364A - PIPER

SERVICE LETTER

Detached or Loose Rubatex Blocks in Wing Panels

PA-24 and PA-24 "250" Comanches - Serial Nos. 24-1 to 24-2264 inclusive

Sketch

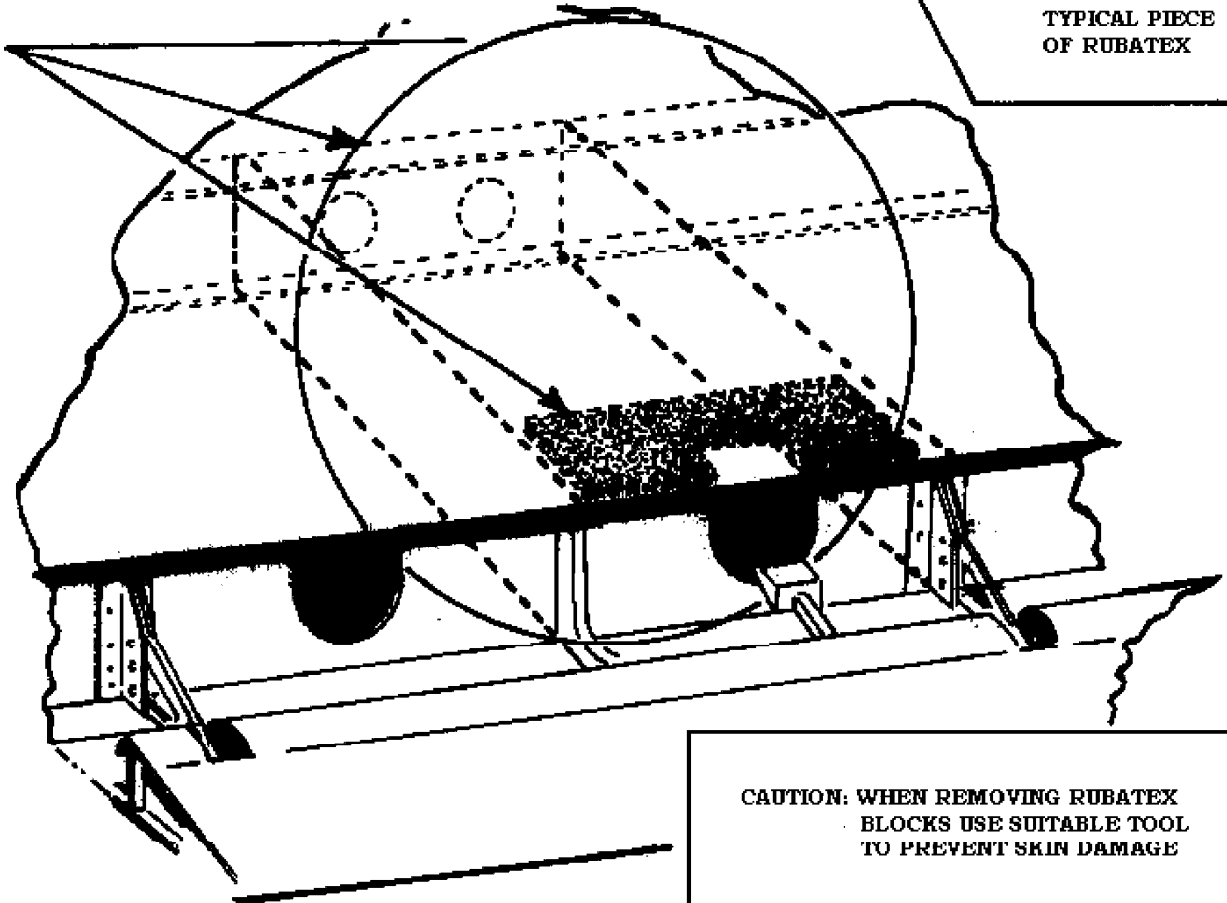
Rubatex blocks were used in a few instances to reduce the tendency of oil canning in the areas of the wing panels, as shown on the sketch on the reverse side of this Service Letter. Prior to but not later than the next 50 hours of operation, this entire area on both wings must be inspected and where these blocks are observed either loose or attached, they are to be removed.

REMOVE ALL RUBATEX FOUND IN
THIS AREA UPPER AND LOWER SKINS

TYPICAL PIECE
OF RUBATEX

CAUTION: WHEN REMOVING RUBATEX
BLOCKS USE SUITABLE TOOL
TO PREVENT SKIN DAMAGE
